Authorized Field Change

AFC 12943R1

Subject: Certain LoneStar® Models with Cummins® ISX15 Engines May Experience Incorrect Sealing on Air Cleaner Intake Pipes

Model: LoneStar® built with Cummins® ISX15 engine

Figure 1. Air Intake Duct Dirt Trails.

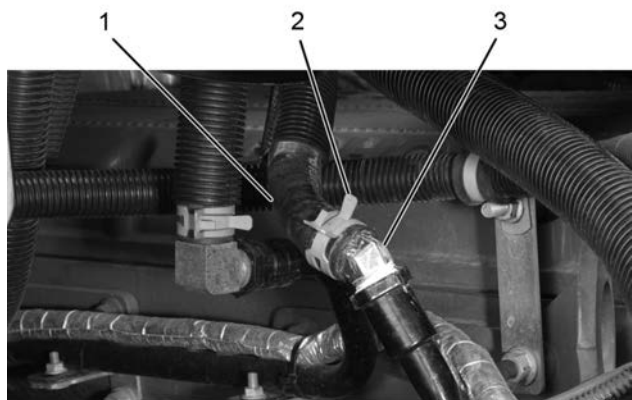
9. Inspect air intake duct for dirt trails (Figure 1).

- If no evidence of dirt trails is present, proceed to Step 10.
- If evidence of dirt trails is present, create an iKNow case file for further instructions (pictures of the dirt trails must be attached to the case file), and proceed to Step 10.

Figure 2. Hose and Attachments.

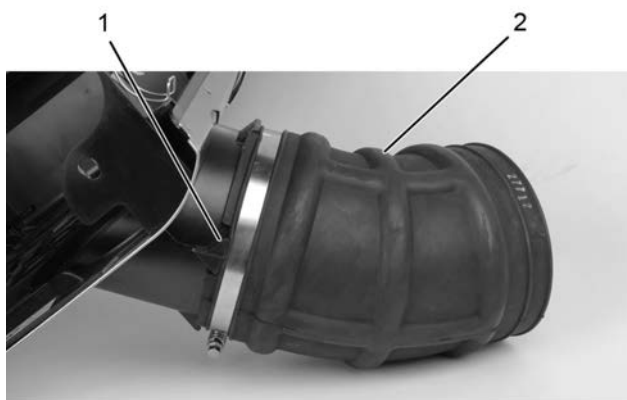
11. Install hose pinch plier to upper heater hose (Figure 2, Item 1).
12. Remove hose clamp (Figure 2, Item 2) from straight fitting in area next to valve cover on right side of engine.
13. Remove upper heater hose (Figure 2, Item 1) from straight fitting.
14. Remove straight fitting.
15. Install new 45° fitting (Figure 2, Item 3). Orient fitting toward rear of engine.
16. Install upper heater hose (Figure 2, Item 1) to 45° fitting (Figure 2, Item 3).
17. Install hose clamp (Figure 2, Item 2) to upper heater hose (Figure 2, Item 1).
18. Remove hose pinch plier from upper heater hose (Figure 2, Item 1).
19. Remove Coolant Management Tool and vacuum.

Figure 3. Rubber Elbow.

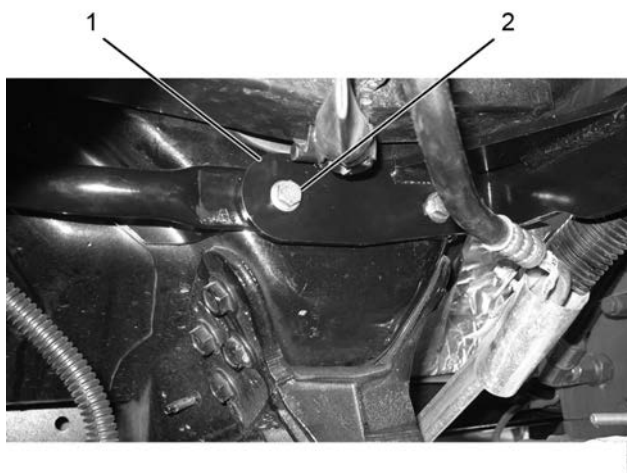
20. Install new rubber elbow (Figure 3, Item 2) on new right-side filter housing, and torque hose clamp to 60 lb-in (7.5 N·m). Observe locator notch (Figure 3, Item 1).

Figure 5. New Intake Assembly.

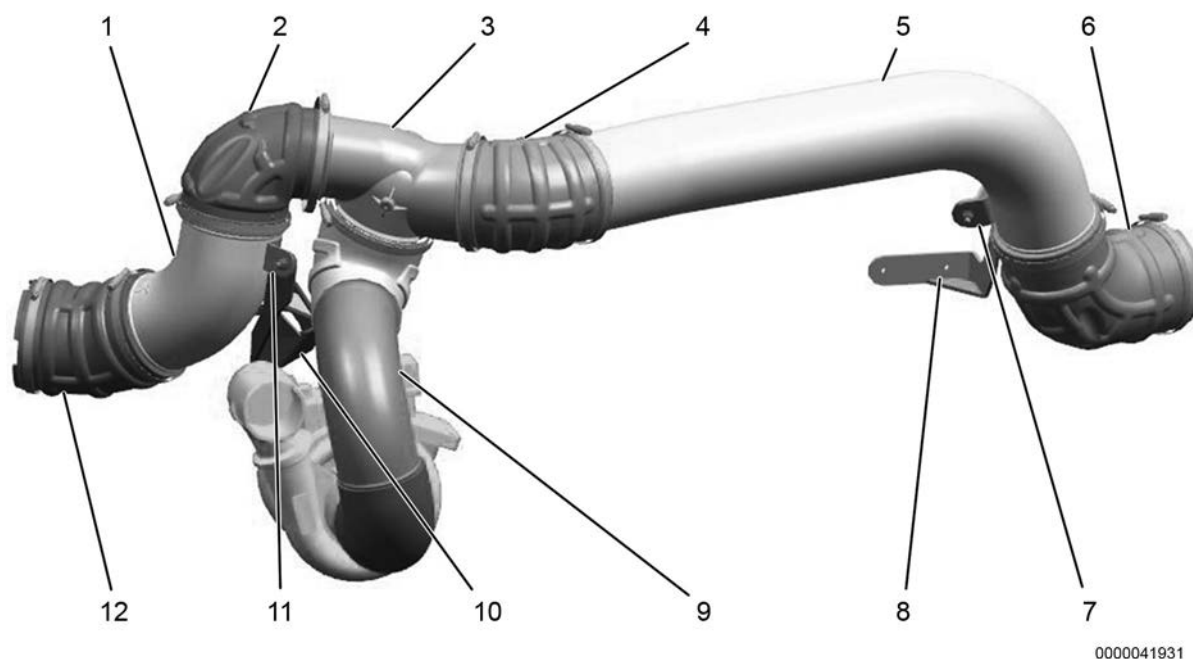
12. New rubber elbow
22. Install right-side mounting bracket (Figure 5, Item 10) onto cab-mount reinforcement brace at lower front of cab. Use 8 mm x 1.25 x 40 flange head bolts (not supplied). Leave bolts loose.

24. Torque six filter housing nuts to 18 lb-ft (25 N·m).
 25. Torque two mounting bracket bolts (Figure 4, Item 2) to 18 lb-ft (25 N·m).
 26. Install new right-side metal elbow (Figure 5, Item 1) into rubber elbow (Figure 5, Item 12) from filter housing.

27. Align right-side pipe mounting tab (Figure 5, Item 11) to right-side mounting bracket (Figure 5, Item 10) and secure using lockwasher and nut. Leave lockwasher and nut loose.

28. Install new right-side upper rubber elbow (Figure 5, Item 2).
29. Install new rubber elbow (Figure 5, Item 6) on new left-side filter housing, and torque hose clamp to 60 lb-in (7.5 N·m). Observe locator notch.

30. Remove two bolts (Figure 4, Item 2) from steel support bracket (Figure 4, Item 1) at left-side cab-mount brace on lower front of cab.
31. Install left-side mounting bracket (Figure 5, Item 8) onto cab-mount reinforcement brace at lower front of cab. Use 8 mm x 1.25 x 40 flange head bolts (not supplied). Leave bolts loose.

34. Torque two mounting bracket bolts (Figure 4, Item 2) to 18 lb-ft (25 N·m).
35. Install new left-side metal elbow (Figure 5, Item 5) into rubber elbow (Figure 5, Item 6) from filter housing.

36. Align left-side pipe mounting tab (Figure 5, Item 7) to left-side mounting bracket (Figure 5, Item 8) and secure using lockwasher and nut. Leave lockwasher and nut loose.

37. Install new rubber elbow upper inlet section (Figure 5, Item 4).
38. Install inlet tee section (Figure 5, Item 3). Adjust pipes and snug clamps.

Figure 6. Turbocharger Inlet Assembly.

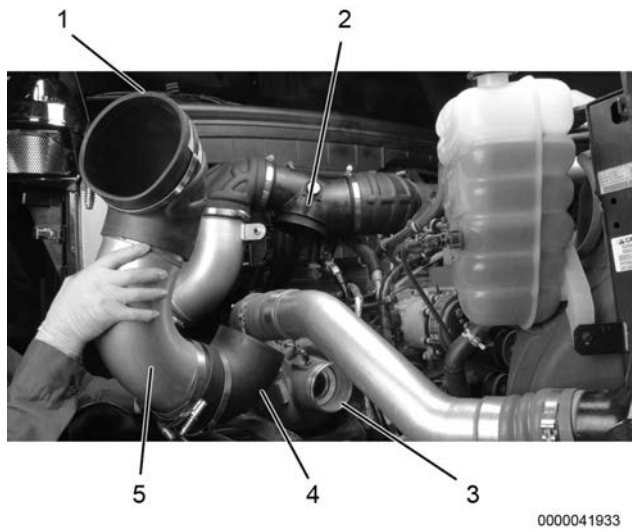
39. Assemble rubber elbow (Figure 6, Item 4), metal elbow (Figure 6, Item 5), and reducer elbow (Figure 6, Item 1) connecting inlet tee section (Figure 6, Item 2) to turbocharger inlet (Figure 6, Item 3).
40. Remove cover cap from turbocharger.
41. Install turbocharger inlet assembly to inlet tee section.

Figure 7. Correct Installation.

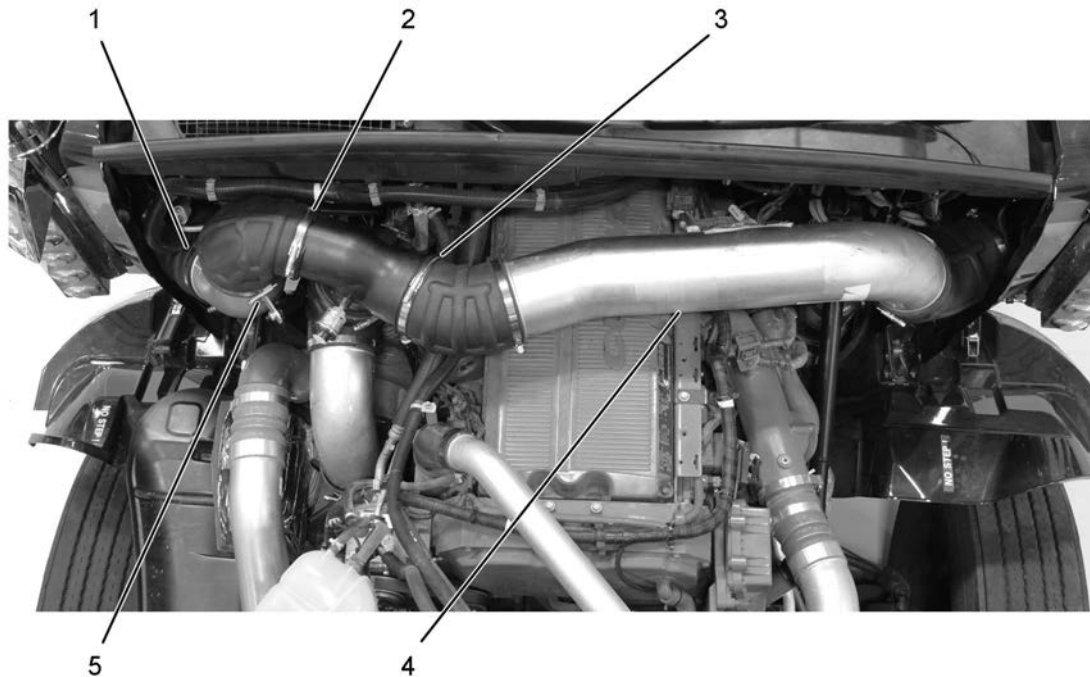
42. Adjust all pipes according to locator notches. Torque all clamps to 60 lb-in (7.5 N·m).

43. When correctly installed, new system should appear as shown (Figure 7).

Figure 8. Rear Hood Brace.

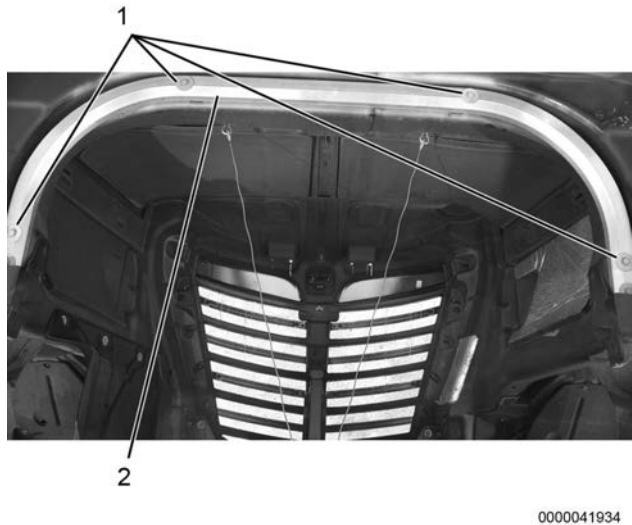
NOTE: Installation of new hood brace is required to achieve proper clearance to new components after hood is closed.

51. Remove six mounting bolts (Figure 8, Item 1) from rear hood brace (Figure 8, Item 2).

52. Remove rear hood brace.

53. Install new rear hood brace.

54. Torque six rear hood brace mounting bolts to 17 lb-ft (23 N·m).
